Mamre Road upgrade between the M4 Motorway and Erskine Park Road

Submissions report

Transport for NSW | July 2022

Projection: GDA2020 MGA Zone 56 Figure 4-1: Design changes to the proposal following exhibition of the REF

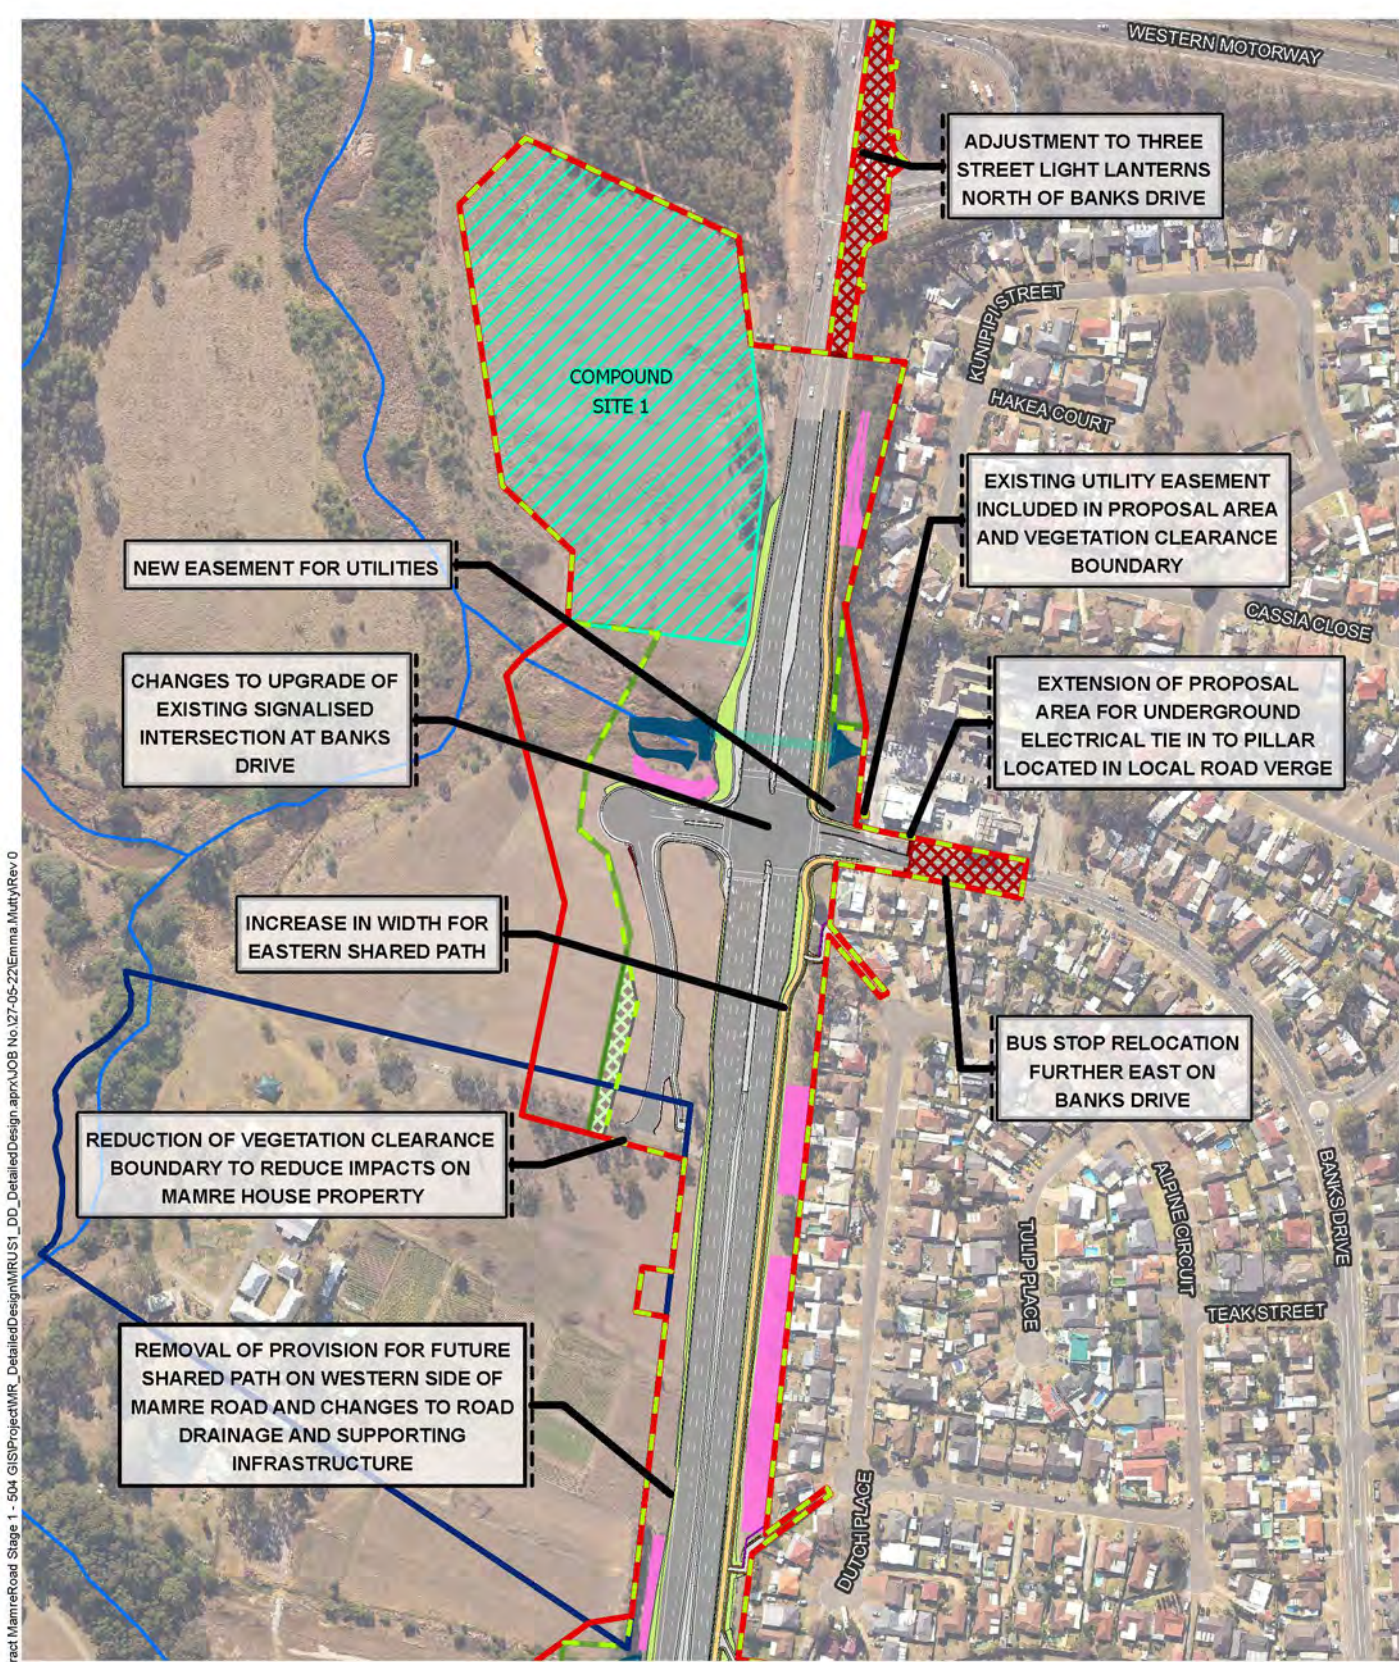
Figure 4-1 indicates the locations where design changes are proposed in the revised design compared to the design outlined in the REF.

- replacement of the space provision for a future shared path on the western side of Mamre Road between Mandalong Close and Banks Drive with a paved shoulder and road verge

Figure 4-2: Changes to Mamre Road / Banks Drive intersection

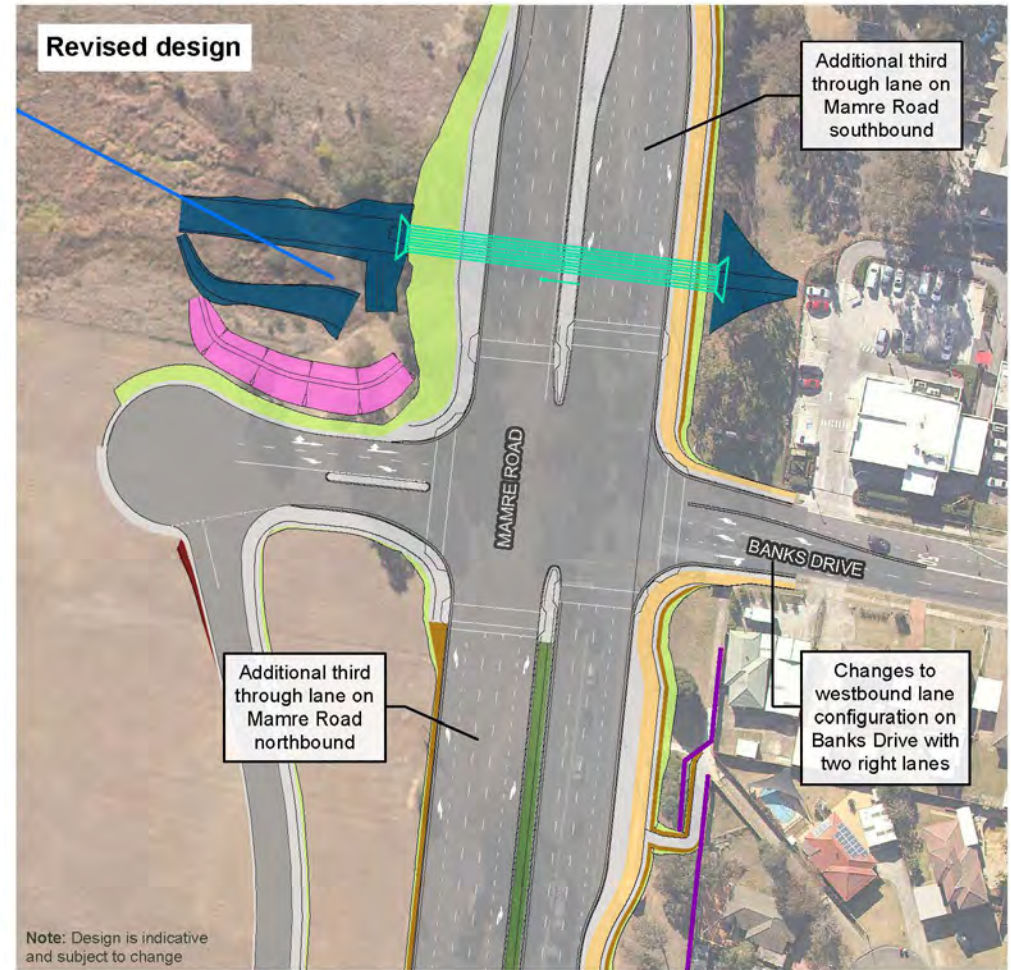
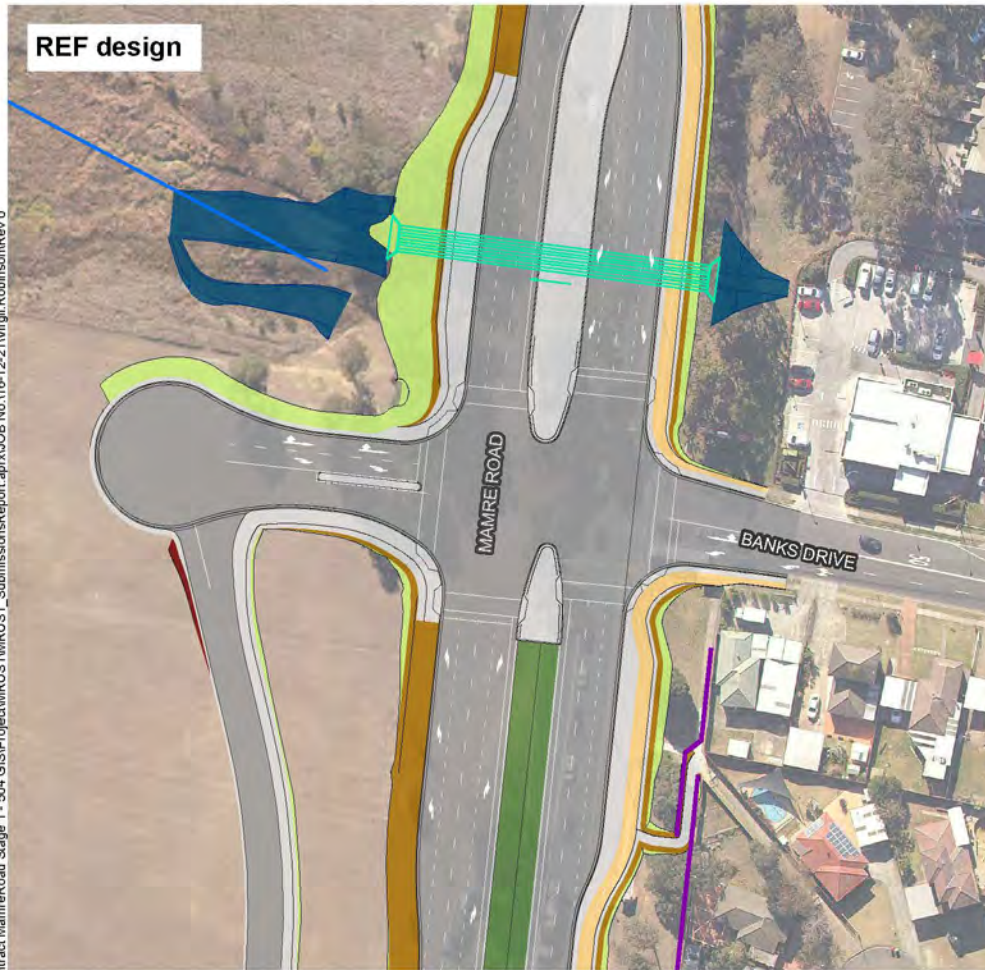
There have been changes made to lane configuration on Mamre Road and Banks Drive at the Banks Drive intersection compared to the REF to improve the traffic performance of this section (refer to Figure 4-2). These changes are in response to community and government agency issues raised during REF display expressing concern about congestion near the Banks Drive intersection (refer to Sections 2.2.1, 2.3.7, 2.5.3 and 3.2.5).

This design change would allow for free flow traffic on the through lanes without the need for lane merges between the Banks Drive intersection and M4 Motorway interchange.

The proposed design speed between the Banks Drive intersection and the M4 Motorway interchange would be reduced from 90 kilometres per hour (as per the REF proposal) to 70 kilometres per hour due to engineering constraints of the road. However, this part of Mamre Road currently has a posted speed limit of 60 kilometres per hour.

The median width has also been reduced, but the reduction has been minimised by removing the road shoulder adjacent to the right turn lanes on Mamre Road near the Banks Drive intersection. Despite this, a

staggered pedestrian crossing was able to be maintained in the revised design. The pedestrian crossing arrangement shown on Figure 4-2 is indicative and would be confirmed during detailed design.
